TECHNICAL MEMORANDUM

Subject: Lake Prevatt Minimum Flows and Levels Peer Review
Task C2: Final Peer-Review Technical Memorandum

Figure 2. Lake Prevatt sub-watersheds (green polygons) delineated by Sarker and others (2023), over the ESRI World Street Map at a local scale.

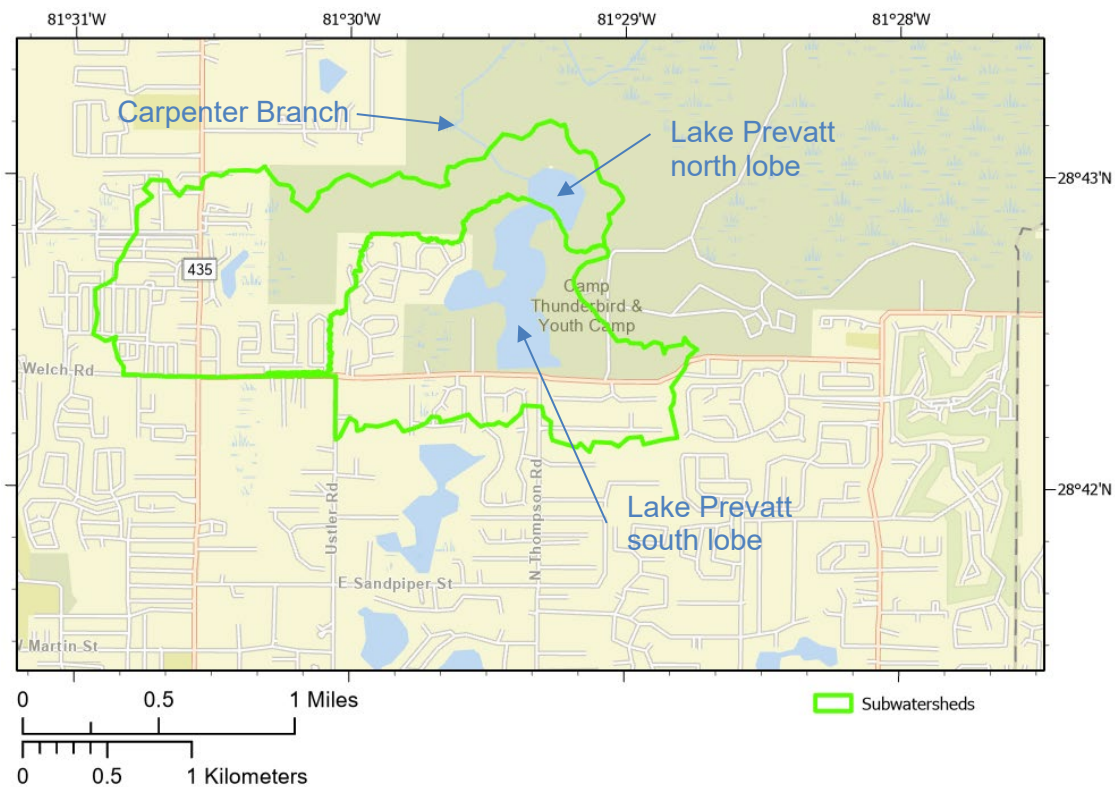
SJRWMD did not simulated flows from Lake Coroni to Lake Prevatt (**Figure 2**).
SJRWMD also did not simulate flows from Lake McCoy to Lake Coroni (**Figure 2**).

SJWMD may wish to re-delineate the watershed that drains to Lake Prevatt to include areas that drain to Lake McCoy (**Figure 5**) and Lake Coroni (**Figure 6**). This re-delineation will conform to observations made by Manager Brooks, that water from Lake Coroni periodically or episodically flows to Lake Prevatt from Lake Coroni. SJRWMD may wish to inform this re-delineation with Professional Engineering Consultants (1997a) and select environmental resource permits (**Table 1**).

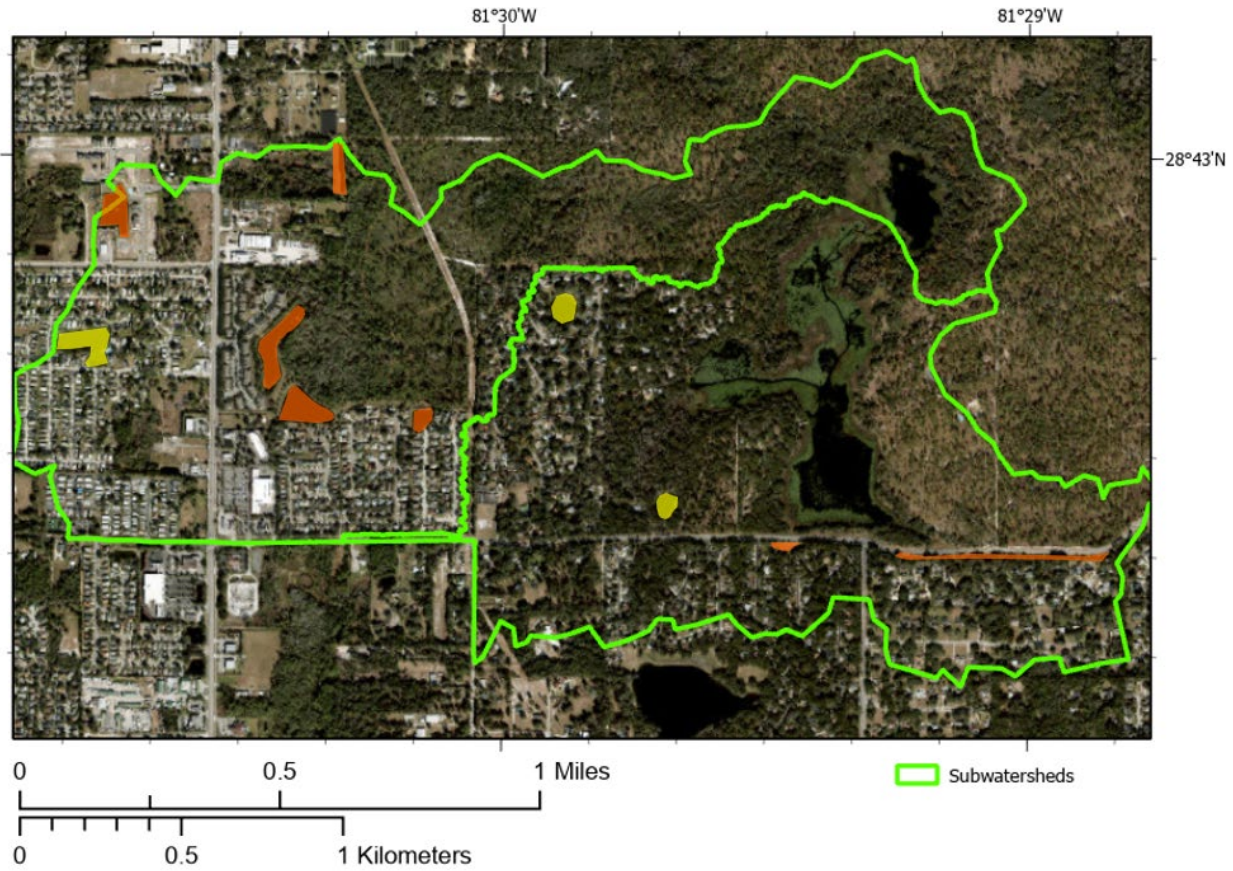
5. Stormwater management systems exist in the Lake Prevatt watershed, which detain or retain stormwater (Figure 8) from the watershed to Lake Prevatt. Natural ponds also exist in the Lake Prevatt watershed. These ponds likely retain or detain surface-water flows from the watershed to Lake Prevatt. SJRWMD may wish to revise the simulation to include constructed stormwater management systems and natural ponds, to quantify detention or retention of surface-water flow to Lake Prevatt.

10. SJRWMD may wish to revise the simulation described in Sarker and others (2023) to include surface-water conveyance infrastructure, stormwater detention infrastructure, stormwater retention infrastructure in areas that drain to Lake Pevatt (comment 5, **Figure 8**).

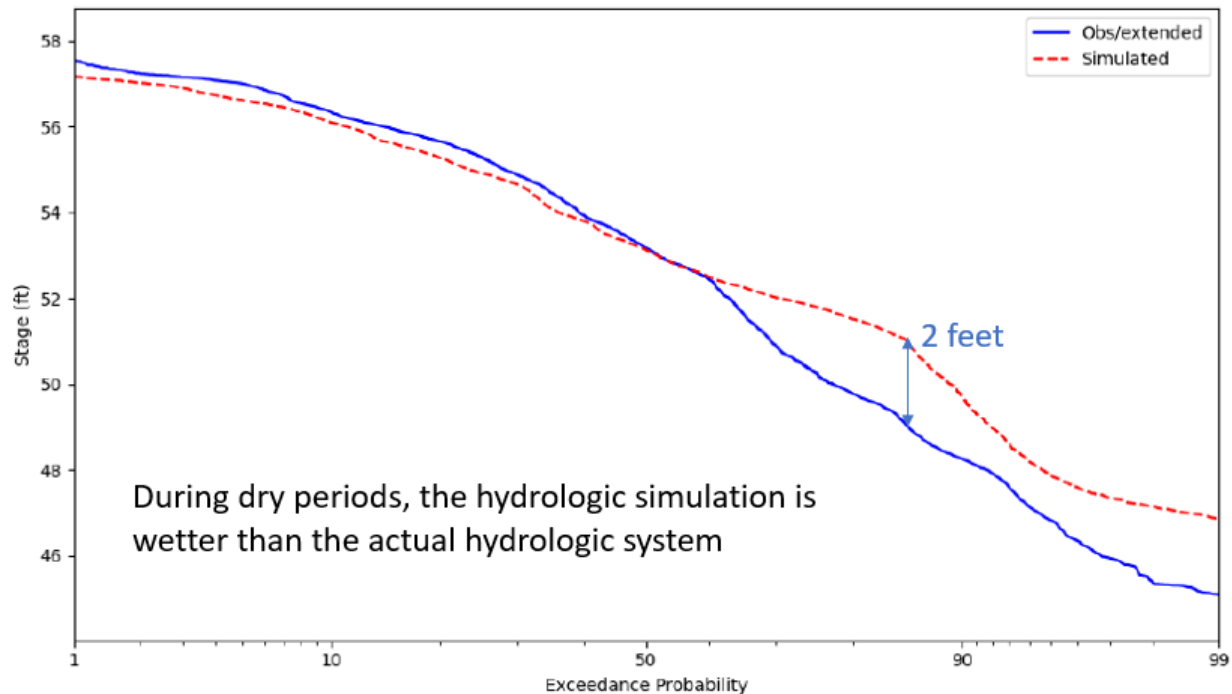
Sarker and others (2023) quantified measured and simulated, Lake Pevatt south lobe water-surface elevation exceedance probability (**Figure 9**). For example, Sarker and others (2023) show that a measured 48-foot water-surface elevation above the North American Vertical Datum of 1988 (NAVD88) has a 90-percent chance of being exceeded from 2008 to 2021. Sarker and others (2023) show that the simulated water surface elevation is as much as two feet greater than the measured water surface elevation, along the relatively lower-elevation, drier side of the elevation-probability relationship. Restated: the simulation is wetter than measurements, during relatively lower stages, less than about 52 feet above NAVD88. Consequently—with the simulation described in Sarker and others (2023)—SJRWMD propose to inform a specified, regulatory, minimum lake level with a tool that is wetter than the actual lake level, at the same exceedance probability.

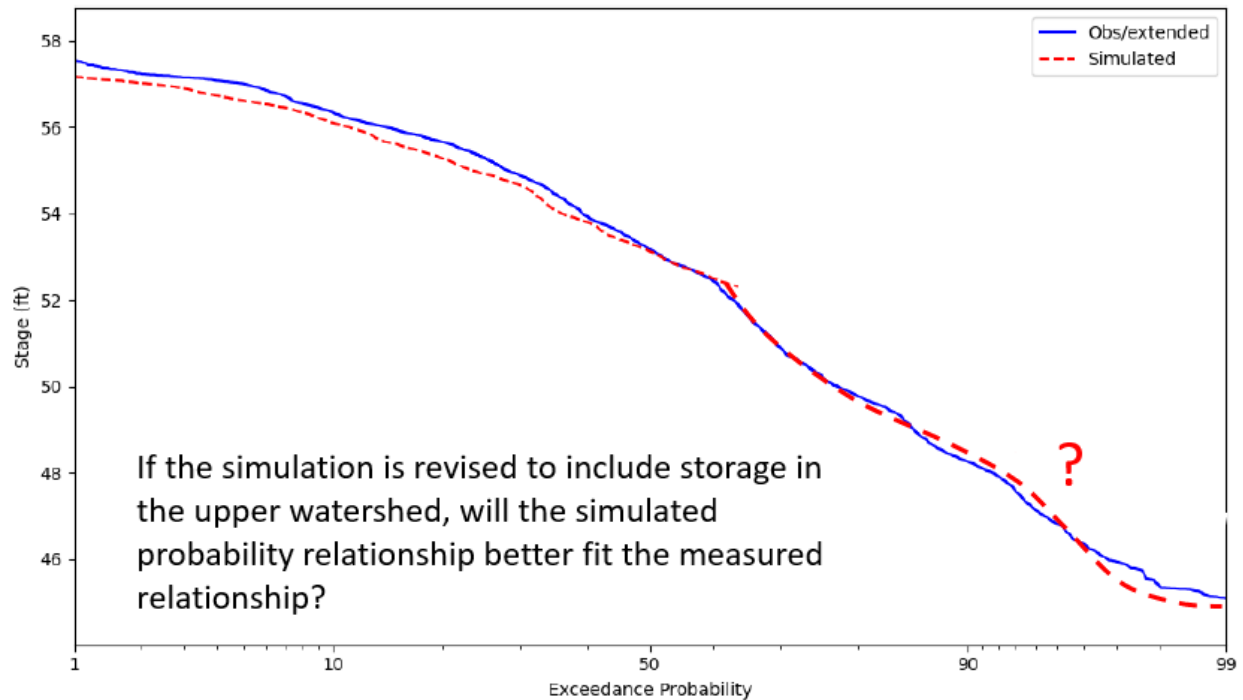
SJRWMD may wish to revise the simulation described in Sarker and others (2023) to include surface-water conveyance infrastructure, stormwater detention infrastructure, and stormwater retention infrastructure in areas that drain to Lake Prevatt. In this revised simulation, some surface water may be detained, or retained in the upper watershed, south of Welch Road East, in the pond in front of Manager Brooks' residence, in a natural pond near Cedar Glen Drive, in stormwater management facilities north of Boulder Creek Court and east of Sunset Palm Drive, in a wetland north of Boulder Creek Court and east of Sunset Palm Drive, in a natural pond west of West Dottie Street, in a stormwater management facility west of Emerald Springs Drive, in wetland west of Tanglewood Lane, and in a wetland west of Jolly Avenue (**Figure 8**). Consequently, the simulated water-surface elevation in Lake Prevatt may be drier along the relatively lower-elevation, drier side of the elevation-probability relationship. If SJRWMD make this revision, the simulated exceedance probability relationship may fit better, the measured exceedance probability relationship along the relatively lower-elevation, drier side of the elevation-probability relationship (**Figure 10**).

Figure 11. Professional Engineering Consultants, Inc., node-reach diagram for a simulation of surface-water flows and elevations an area near Welch Road East.

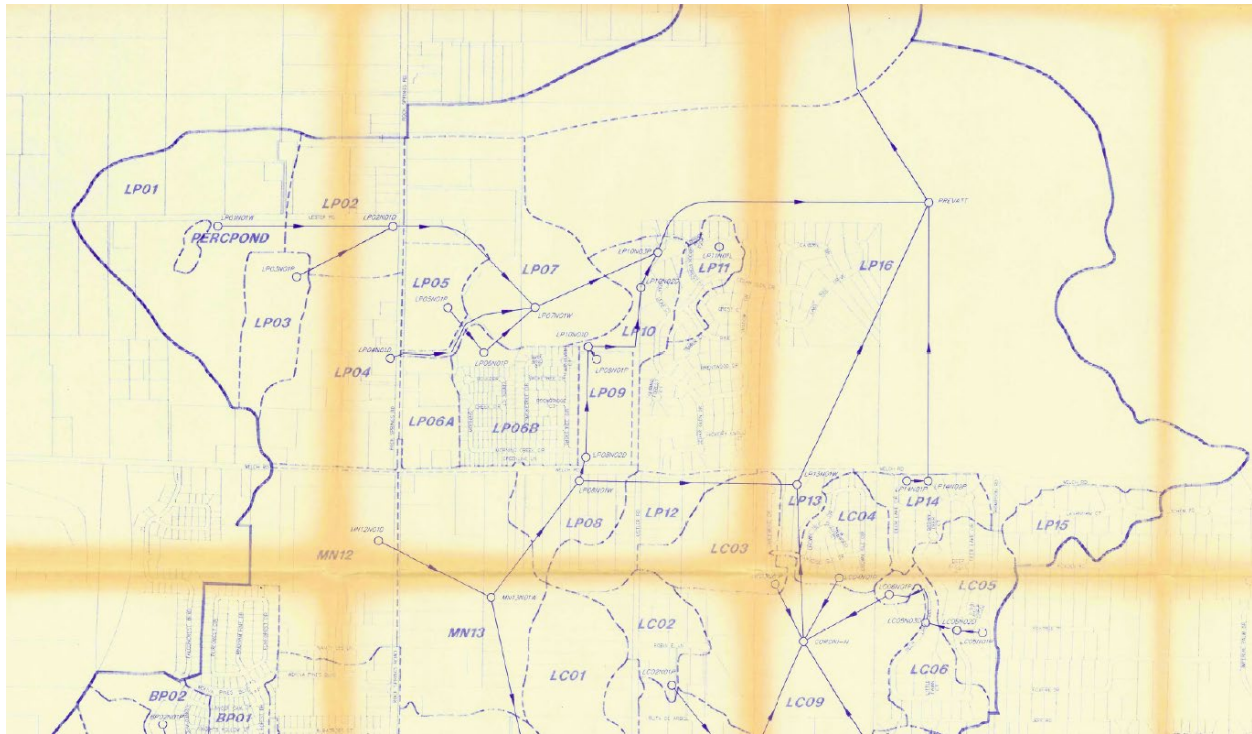
11. Sarker and others (2023) did not delineate wetland west of Tanglewood Lane, a wetland west of Jolly Avenue, and a wetland south of Welch Road East between Rock Springs Road and Ustler Road as draining to Lake Prevatt. Professional Engineering Consultants (1997a) delineated (**Figure 11**) wetland west of Tanglewood Lane (basin LP01), a wetland west of Jolly Avenue (basin LP01), and a wetland south of Welch Road East between Rock Springs Road and Ustler Road (basins MN13, LP08, and LP12) as draining to Lake Prevatt. SJRWMD may wish to re-delineate and refine sub-watersheds to include these areas as draining to Lake Prevatt, and revise the simulation described in Sarker and others (2023) accordingly.

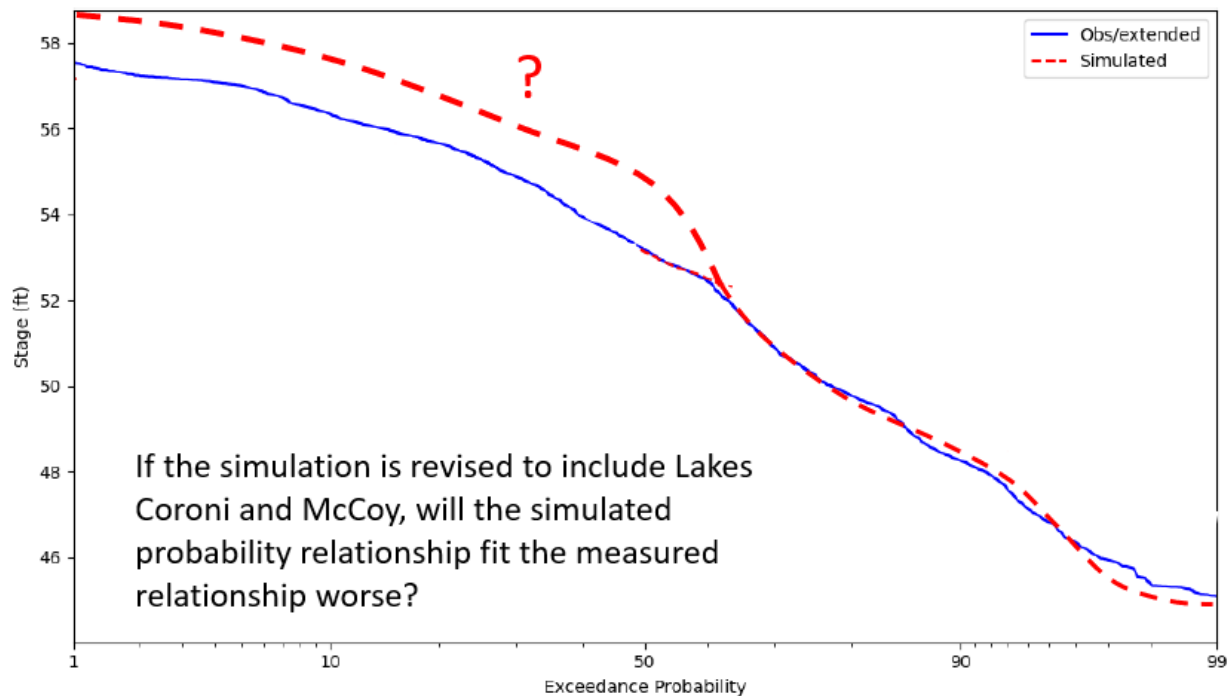
12. Sarker and others (2023) did not delineate areas that drain to Lake Coroni or Lake McCoy as periodically draining to Lake Prevatt, during, for example, rare, episodic events with annual exceedance probabilities greater than, say, 30 percent. Professional Engineering Consultants (1997a) delineated (**Figure 11**) areas that drain to Lake Coroni and Lake McCoy as draining to Lake Prevatt (**Figure 4**).

If SJRWMD make this revision the simulated exceedance probability relationship may change (**Figure 12**).

SJRWMD may wish to delineate areas that drain to Lake Coroni and Lake McCoy as draining to Lake Prevatt. SJRWMD may wish to revise the simulation described in Sarker and others (2023) to include Lake McCoy and Lake Coroni watersheds, and simulate the influence of surface-water conveyance infrastructure, stormwater detention infrastructure, stormwater retention infrastructure in areas that drain to Lake McCoy and Lake Coroni on water-surface elevations in Lake Prevatt.

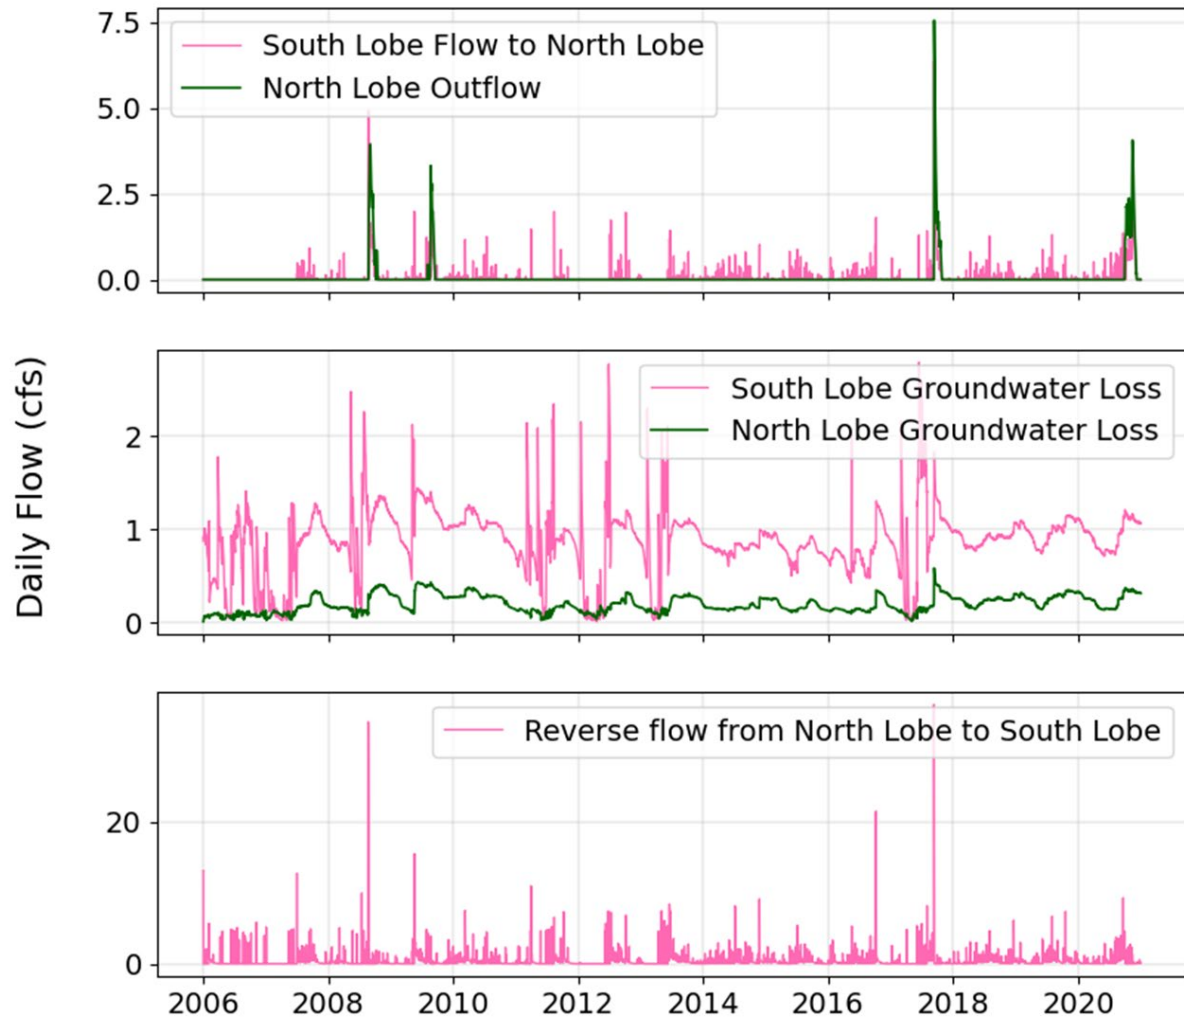
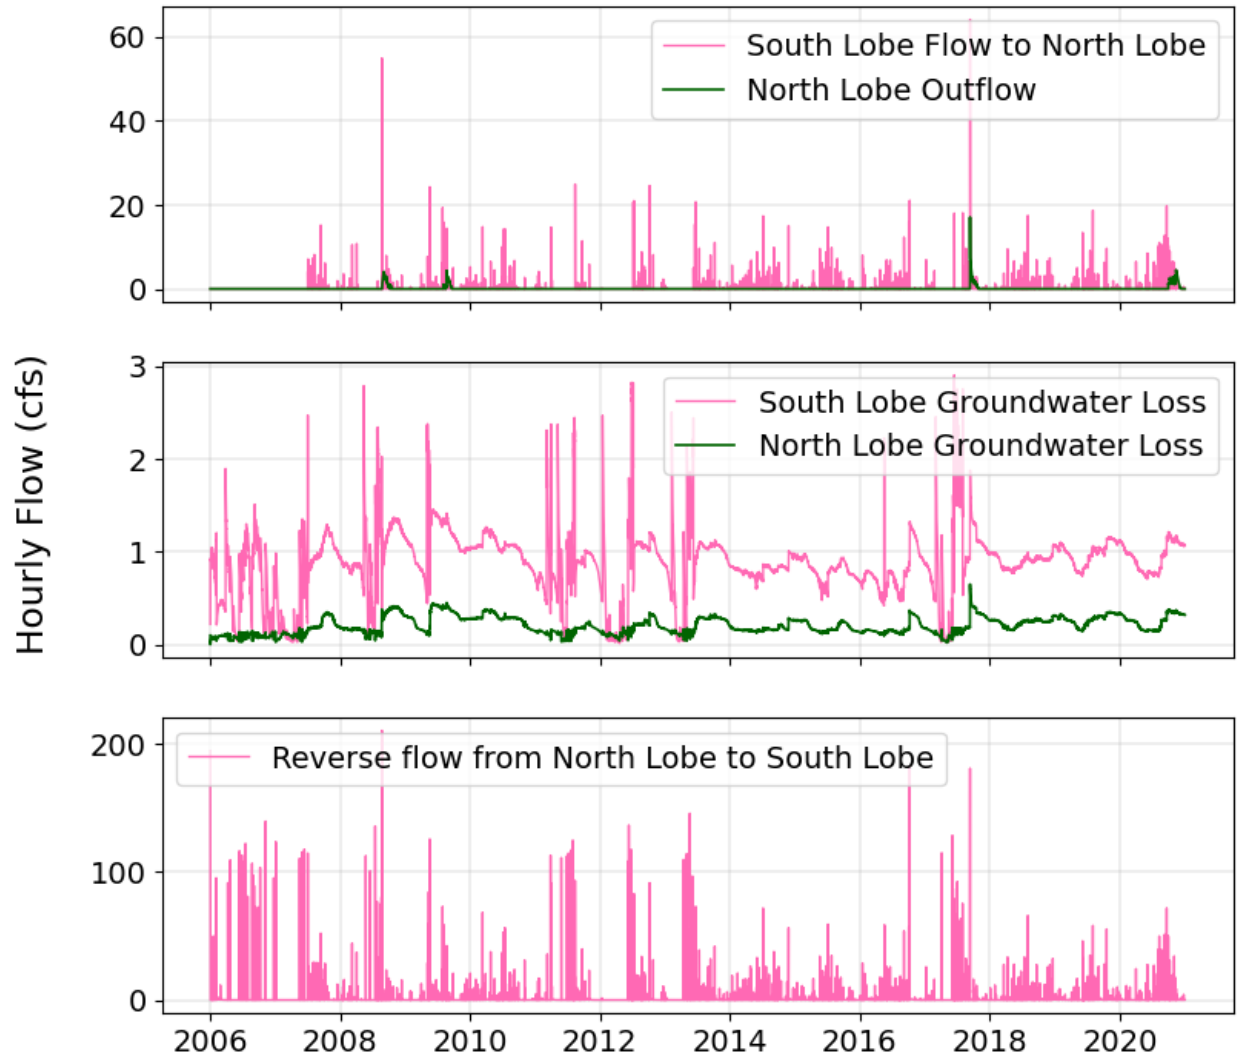
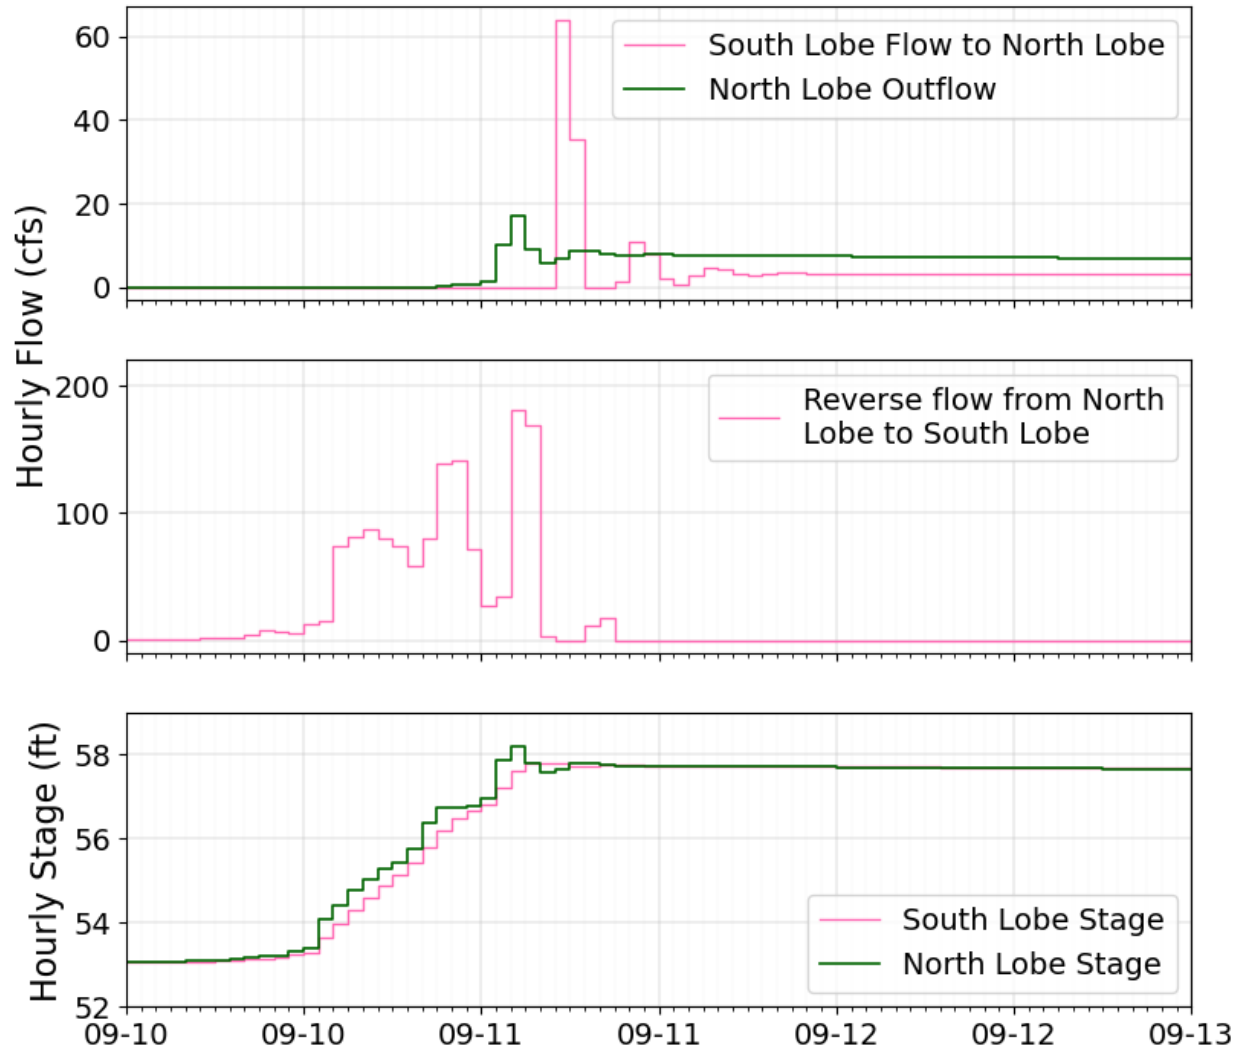
32. Sarker and others (2023) used a one hour computational time step. Maximum flow rate from the Lake Prevatt south lobe to the north lobe was about 60 cubic feet per second, calculated at a one hour resolution, for one hour in late 2017 (**Figure 15**). Integrated over one day, this maximum reduces to less than 2.5 cubic feet per second (**Figure 14**). Maximum flow rate from the Lake Prevatt north lobe to the south lobe was about 200 cubic feet per second, calculated at a one hour resolution, for one hour in 2008 (**Figure 15**). Integrated over one day, this maximum reduces to about 35 cubic feet per second (**Figure 14**). Both the 60 cubic foot per second flow rate from the south lobe to the north lobe and the 200 cubic

foot per second flow rate from the north lobe to the south lobe are, intuitively, not likely. The computational time step may contribute to these, perhaps, unrealistic flows from one lake lobe to the other lake lobe. Plotting one event at an hourly plot resolution (**Figure 16**) shows that stage differences of tenths of one foot force hourly flow rates of hundreds of cubic feet per second. SJRWMD may wish to reduce the computational time step from one hour to, perhaps, 15 minutes or 5 minutes. This shorter duration computational time step may allow water-surface elevations to equilibrate, reducing the duration over which a head difference between lobes is maintained. This relatively shorter computational time step may reduce peak flow rates between lobes.
